Access Compliance Report Public Rights-of-Way (Curb Ramps)

Main Street: LAURELHURST_ST		Cross Street: WALDEN_ST		Location:	SW
ADA ID: RPRK211118115327	Ramp Type: Type 4 - Parallel	Initial Pass/Fail: Fail	Overall Compliance: No	Severity Score:	32
Codes/Mitigation Info/Possible Solution			Field Measurements/Component Compliance

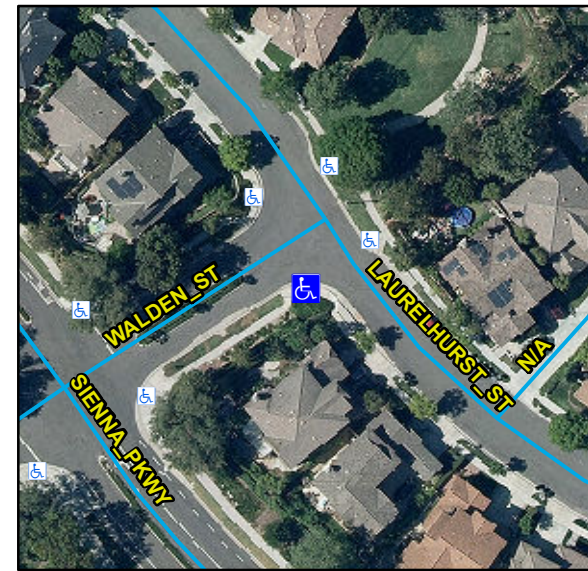
Compliance	Description	Data	Compliance	Description	Data
N/A	Ramp Length LT (in)	115	N/A	Ramp Length RT (in)	114
Yes	Ramp Width LT (in)	54	Yes	Ramp Width RT (in)	54
No	Ramp Run Slope LT (%)	12.2	Yes	Ramp Run Slope RT (%)	0.8
No	Ramp Cross Slope LT (%)	2.7	Yes	Ramp Cross Slope RT (%)	0.9
N/A	Landing Present	N/A	N/A	DWS Provided	N/A
N/A	Landing Length (in)	N/A	N/A	DWS Contrast	N/A
N/A	Landing Width (in)	N/A	N/A	DWS Length (in)	N/A
N/A	Landing Run Slope (%)	N/A	N/A	DWS Full Width	N/A
N/A	Landing Cross Slope (%)	N/A		DWS Offset Type	N/A
N/A	Landing Movement Obstructed?	N/A	N/A	DWS Offset Left (in)	N/A
	Landing Movement Type	N/A	N/A	DWS Offset Right (in)	N/A
N/A	Landing Shared	N/A			
N/A	Clear Space	Yes			
N/A	Clear Space To Crosswalk (in)	N/A			
N/A	Marked Crosswalk 1	No	N/A	Marked Crosswalk 2	No
	Crossing 1 Direction	E		Crossing 2 Direction	N
	Marked Crosswalk 1 Width (in)	N/A		Marked Crosswalk 2 Width (in)	N/A

Remove & Replace Curb Ramp With Two New Directional Ramps or Equivalent.
